RICHLAND COUNTY
PLANNING COMMISSION

FEBRUARY 7, 2005

**RICHLAND COUNTY PLANNING &
DEVELOPMENT SERVICES DEPARTMENT
PLANNING COMMISSION SUBDIVISION STAFF REPORT**

Applicant: Motley & Peake, LLC		Preliminary Subdivision Plans For: Canary Woods, Phase 1
RC Project # : SD-05-115		
General Location: Padgett Road, 1/2 mile west of Lower Richland Blvd		
Tax Map Number: 22015-02-01; 22016-01-03/06/07 22012-02-02; 22019-01-09; 220109-02-05		Current Zoning: RS-2 & RS-3
Subject Area: 23 acres	Number of Units: 63	Gross Density: xxx DU/acres
Sewer Service Provider: City of Columbia		Water Service Provider: City of Columbia

SD 05-115 CANARY WOODS S/D, PHASE 1

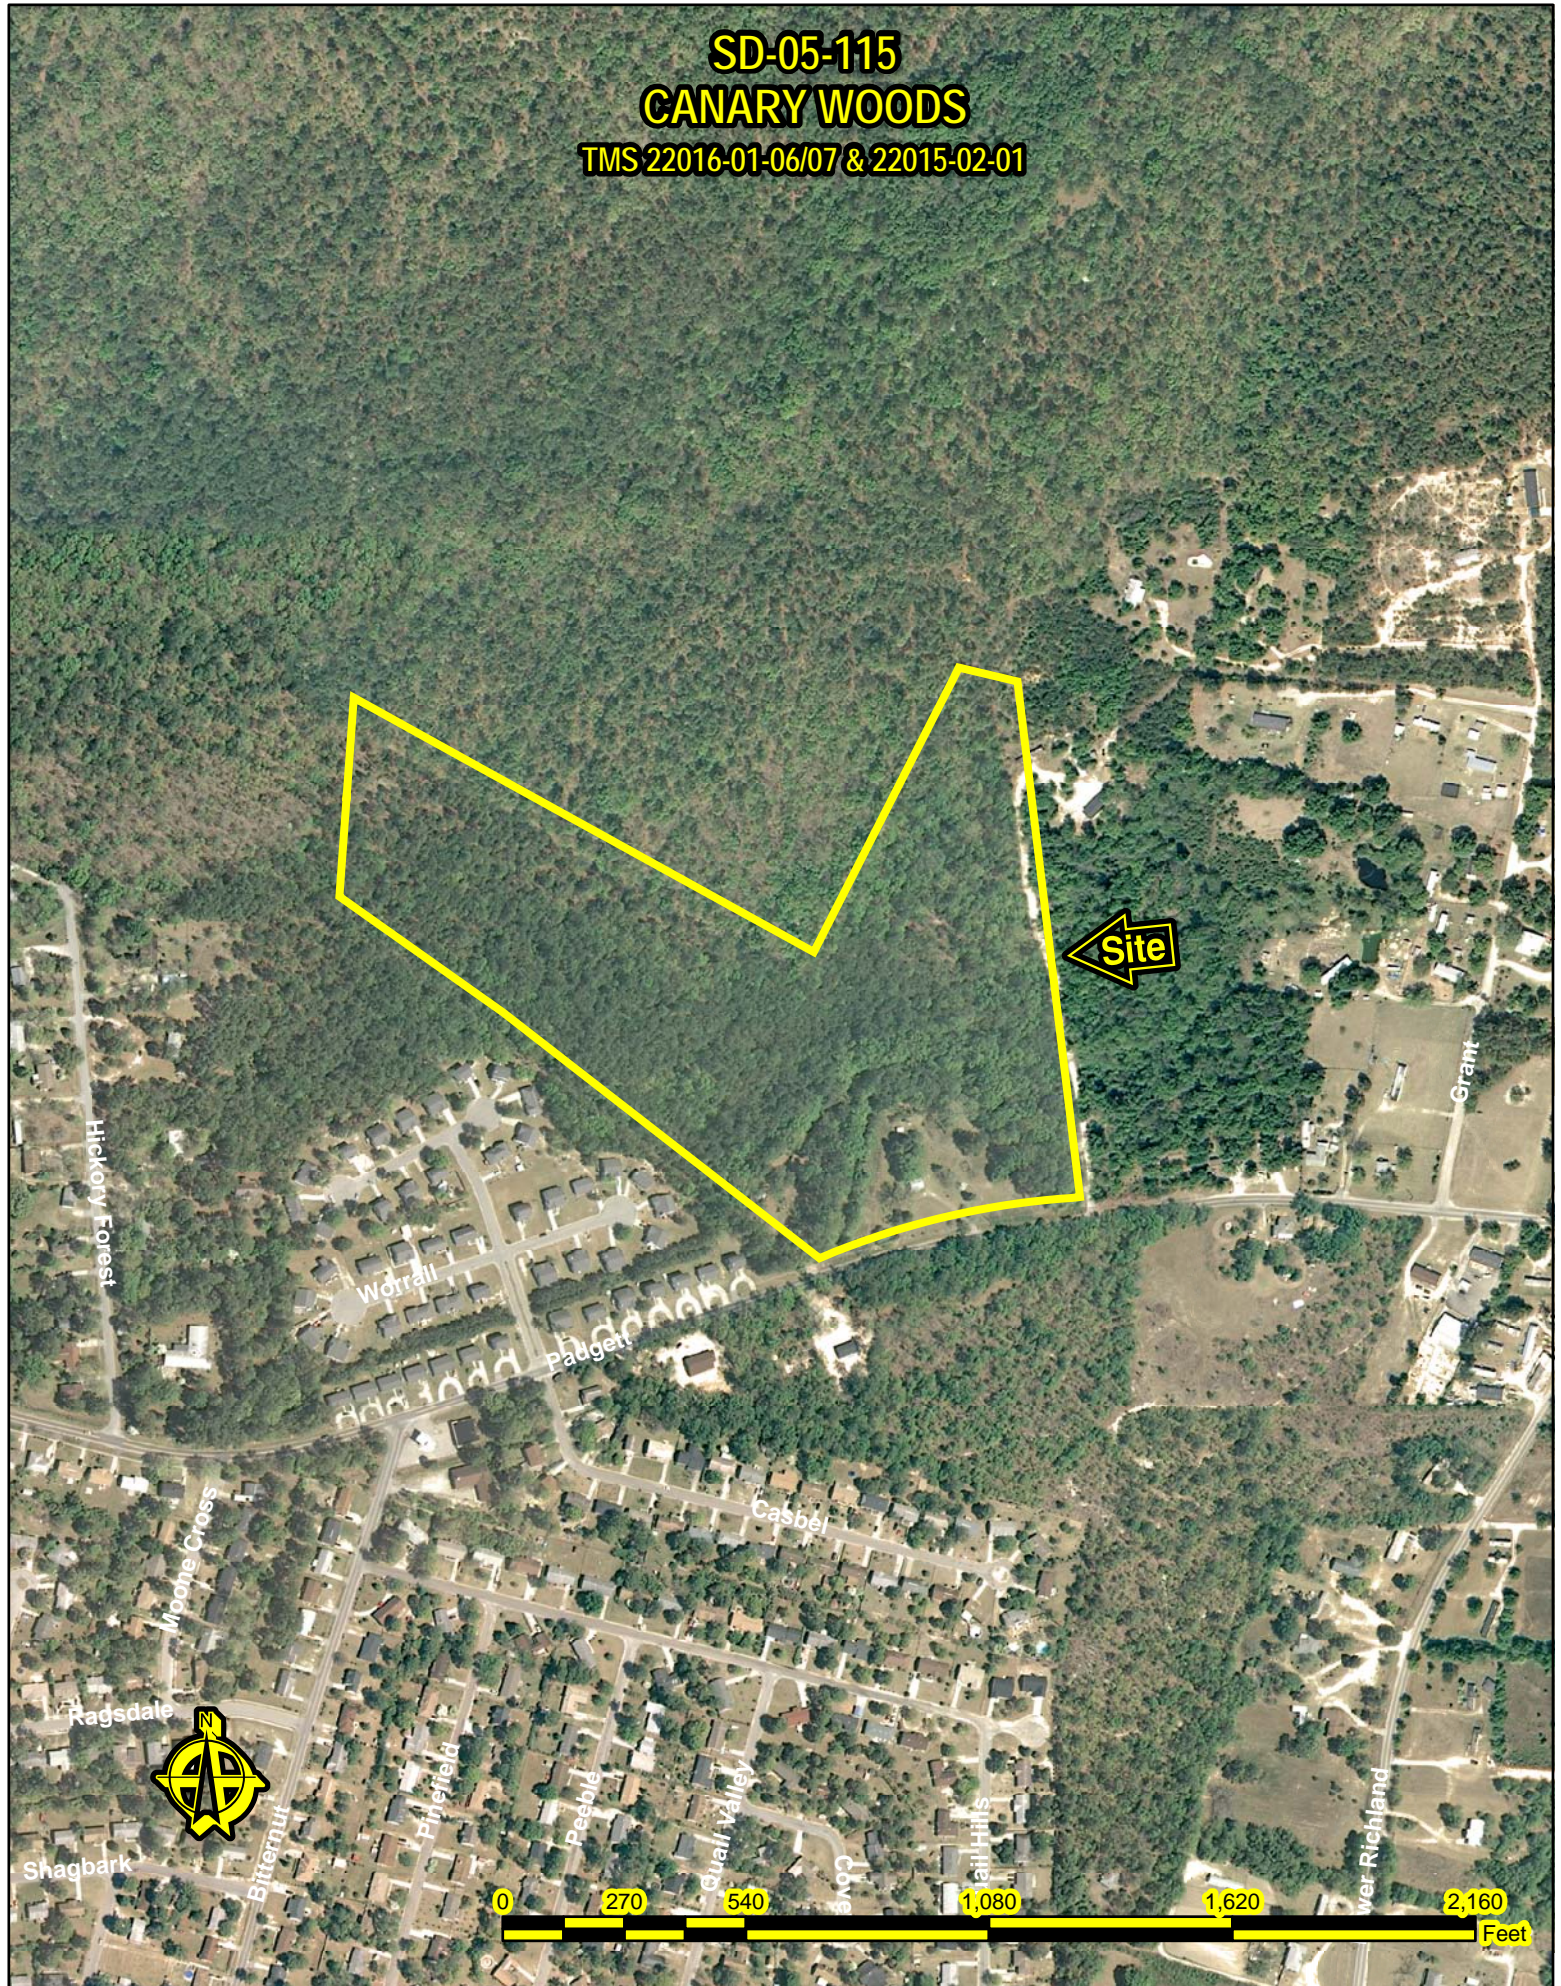
The plans submitted for phase 1 of this project are NOT substantially in conformance with the approved Sketch Plan as required by Chapter 22-11 (f) of the County Code. The missing items listed below were identified in the Department's letter to the applicant regarding the Sketch Plan on November 23, 2004, hereafter referred to as the Letter:

- 1) No phasing plan was provided as required by Comment # 5 in the Letter. The plat, or staking plan, must be revised in this regard.
- 2) The Phase 1 lot numbers were changed to be consecutive within phase 1 rather than retaining the consecutive lots numbers for the whole project provided in the Sketch Plan and as required by Comment 6 in the Letter. The revised staking plan must be revised in this regard.

The zoning for the proposed Canary Woods S/D is NOT all RS-2. Only 3 of the 7 tax parcels involving the entire project were rezoned to RS-2 by Ordinance # 019-04 HR on April 20, 2004. The remaining 4 tax parcels remain zoned RS-3. In order to ensure that building permits are issued in compliance with the lot dimension requirements for the appropriate zoning district, the entire project phasing plan discussed above, and the plat/staking plan, must be revised so that no lots or phases are located in two zoning districts.

The phase 1 plat identified 52 acres of RS-2 zoning, but the application form identifies only 23 acres of RS-2 zoning. Ordinance # 019-04 HR rezoned 23 acres from RR and RS-3 to RS-2. The phase 1 plat must be revised to show 23 acres of RS-2 zoning.

The RS-2 zoning district requires a minimum lot width of 60 feet at the front building line. Lots 2, 3, 4, 5, 6, 15 & 26 do not have 60 feet of lot width at the front setback line. The plat needs to be revised to move the front setback line on these lots back away from the street until 60 feet of lot width is achieved at the front building line.

In the Sketch Plan comment letter described above, the Department suggested that the applicant identify the 100-year elevation of the two creeks that traverse the project because no building permits can be approved until 100-year flood elevation is approved by the Department. The proposed plat for phase 1 shows some common area along the creek, but does NOT delineate the 100-year flood elevation line. In addition, the applicant should be aware that significant revision to the proposed plat, including but not limited to renumbering ALL the lots in the whole project, may be required to accommodate the 100-year elevation line.
